ADDENDUM NO. 1

Date: May 20, 2019

Project: 0108-418, Ethel I. Baker Asphalt Replacement

C1.1

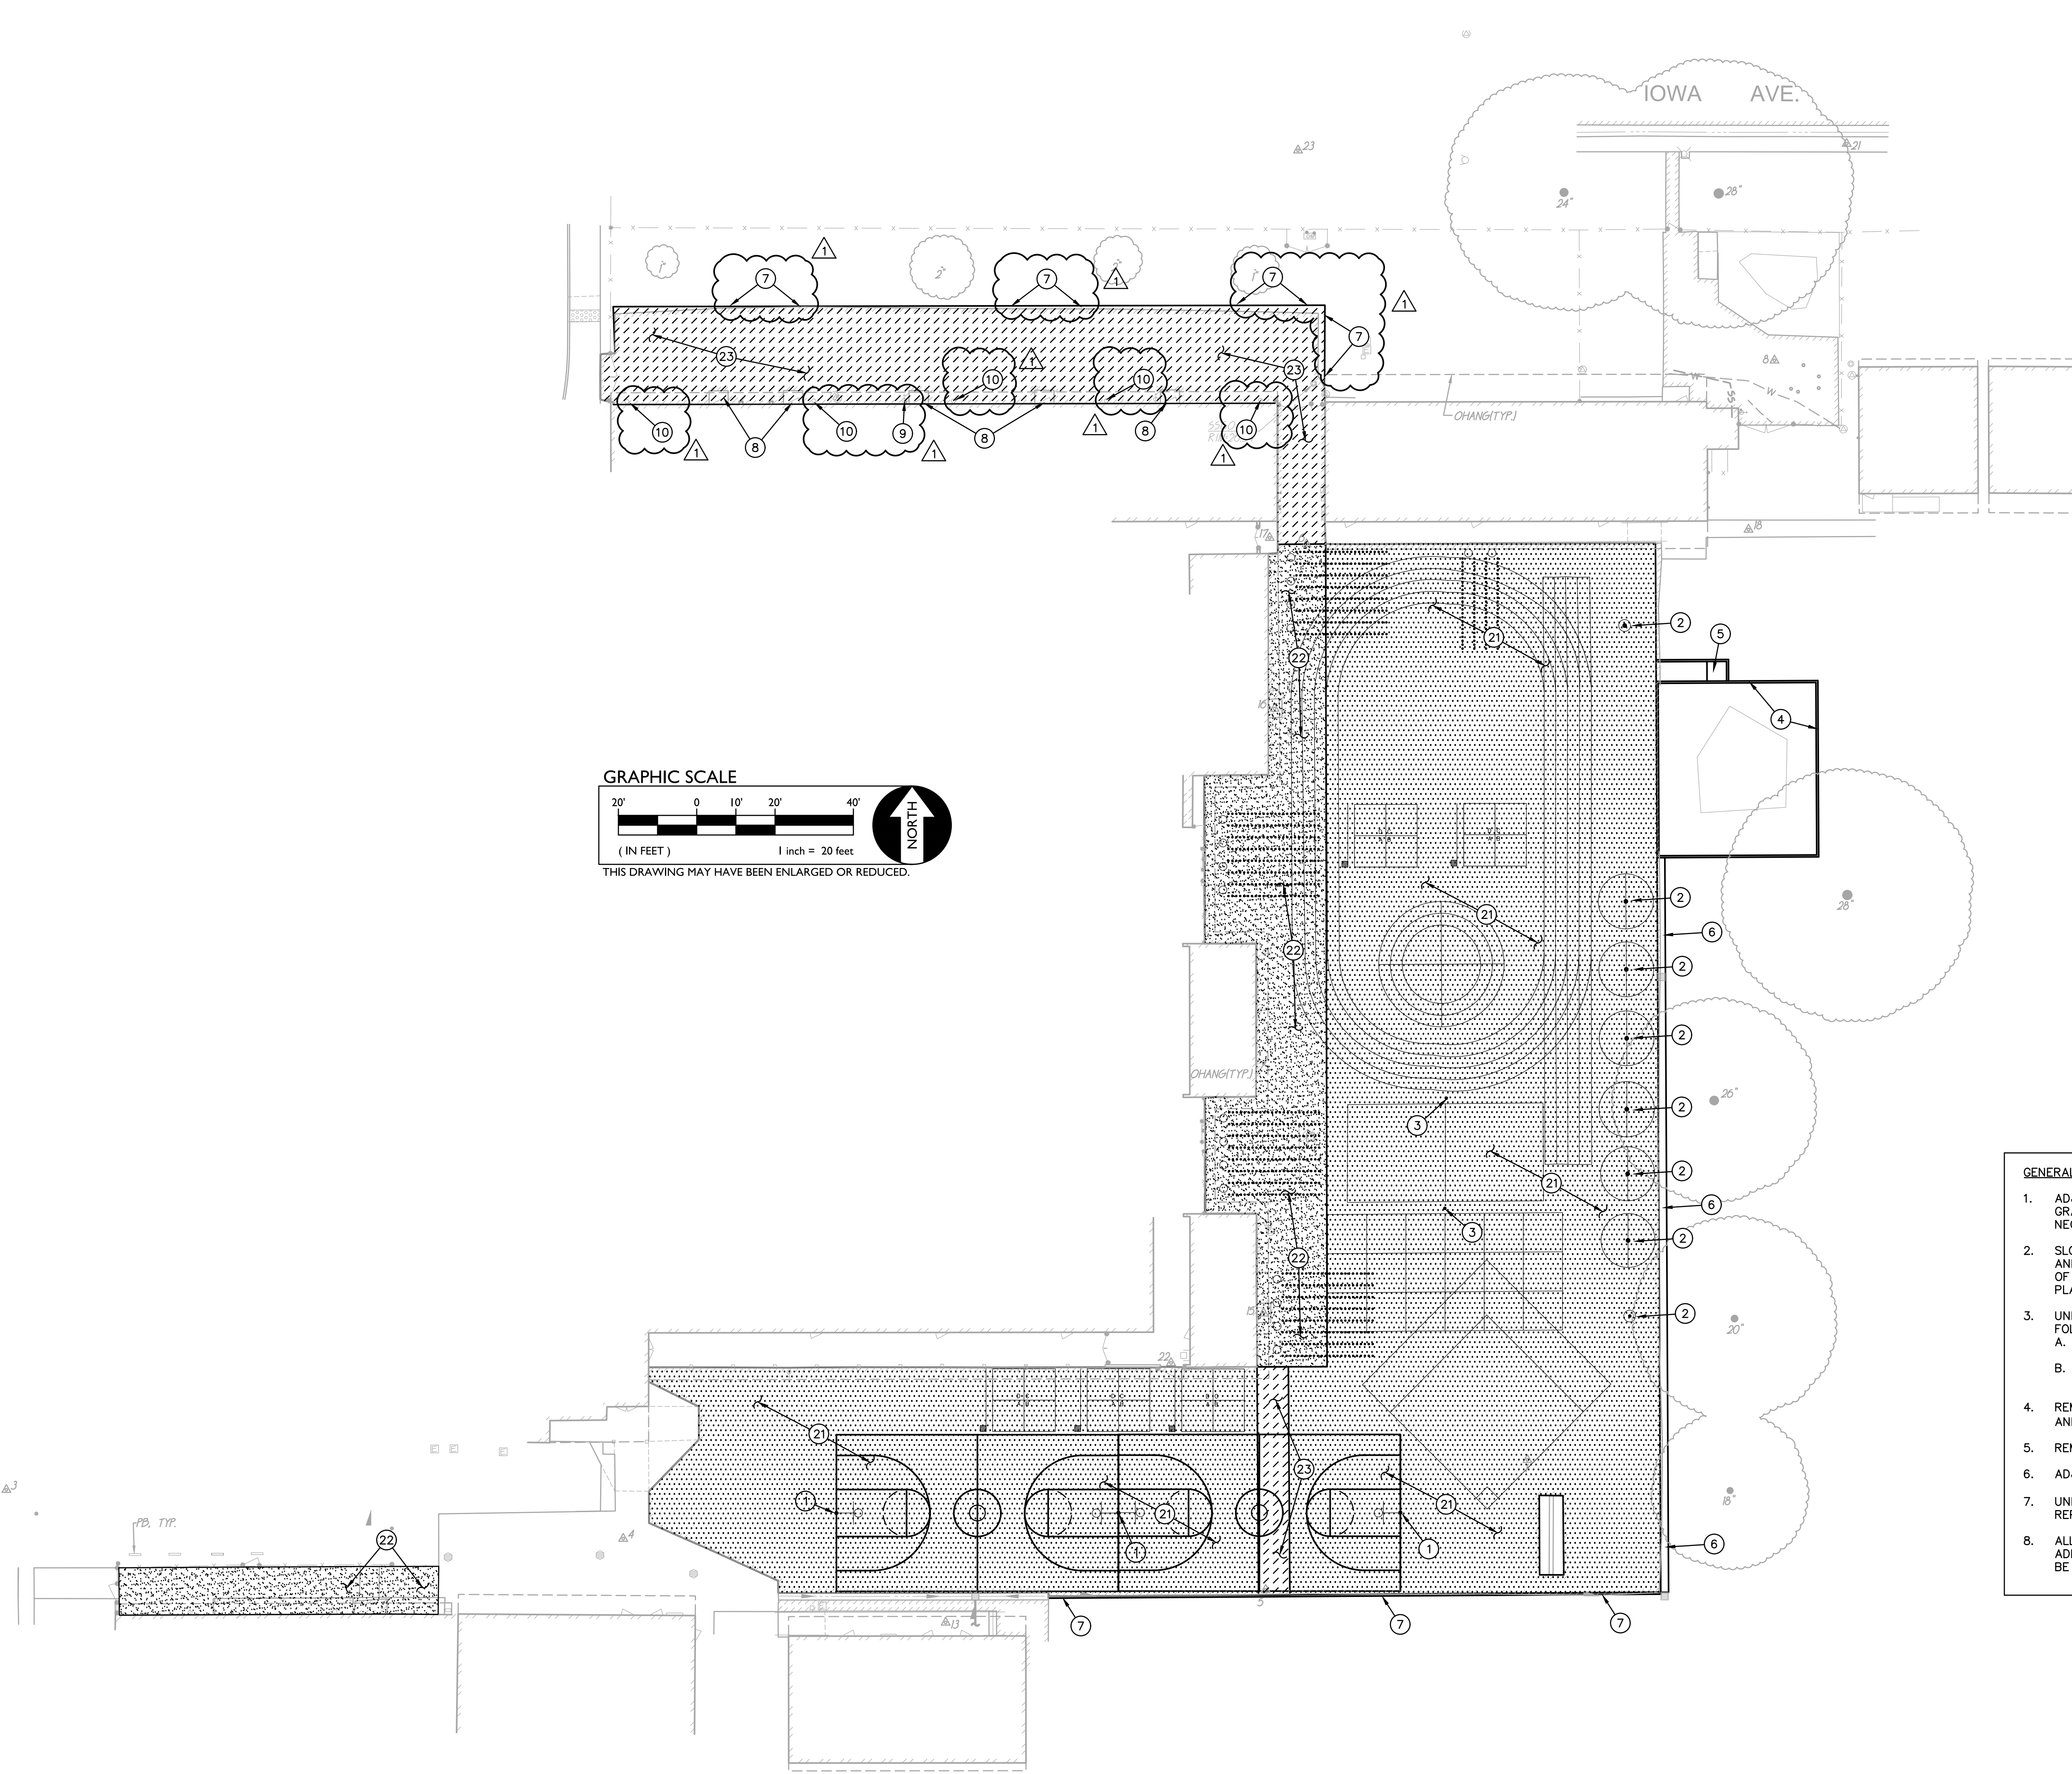
#	Bidder Name	Date Asked	Question	Response
1	McGuire & Hester	5/14/2019	Demolition plan, Sheet C1.1 shows a note No.12 but there is no description. Please clarify.	See addendum sheet C1.1. Note 12 to read "Remove volleyball post and footing".
2	McGuire & Hester	5/14/2019	In Section 321200 Asphalt Concrete Paving, paragraph 2.01.E calls for the AC aggregate at Playcourt to be 3/8 maximum grading. Is this correct?	Yes, the hardcourt aggregate shall be 3/8"
3	McGuire & Hester	5/14/2019	Also in Section 321200 Asphalt Paving, paragraph 3.03.C.1 calls for the Seal Coat to be applied no sooner than 30 days after AC placement. This will put this operation potentially past the time of completion of 60 calendar days and therefore the contractor in a position to pay liquidated damages. Please reconsider this requirement.	The sealcoat will be deleted from the contract.
4	McGuire & Hester	5/14/2019	Construction note 8 on sheet C3.1 indicates to provide a new threshold in concrete at the 5 classroom doors on the north side of the building. Do we need to pour 5 new concrete landings at those locations? Please clarify.	Only enough concrete to install a new threshold is required.

- DEMOLITION NOTES
1. REMOVE AND DISPOSE OF EXISTING AC PAVING AND BASE ROCK.
 2. REMOVE AND DISPOSE OF EXISTING BASKETBALL POST, FOOTING AND BACKBOARD.
 3. REMOVE AND DISPOSE OF EXISTING TETHERBALL POST.
 4. EXISTING BALL WALL TO REMAIN AND BE PROTECTED.
 5. REMOVE AND DISPOSE OF EXISTING APPARATUS RETAINING WALL.
 6. APPARATUS EQUIPMENTMENT TO REMAIN AND BE PROTECTED.
 7. REMOVE AND SALVAGE EXISTING BALL GAME POST FOR REINSTALLATION AFTER PAVING WORK IS COMPLETED.
 8. CAP WATER VALVE BELOW FINISH GRADE.
 9. REMOVE AND REPLACE CLEANOUT PER ¹C1.1
 10. REMOVE AND SALVAGE GATE FOR REINSTALLATION AFTER PAVING WORK IS COMPLETED.
 11. REMOVE CONCRETE PAVING.
 12. REMOVE VOLLEYBALL POST AND FOOTING.
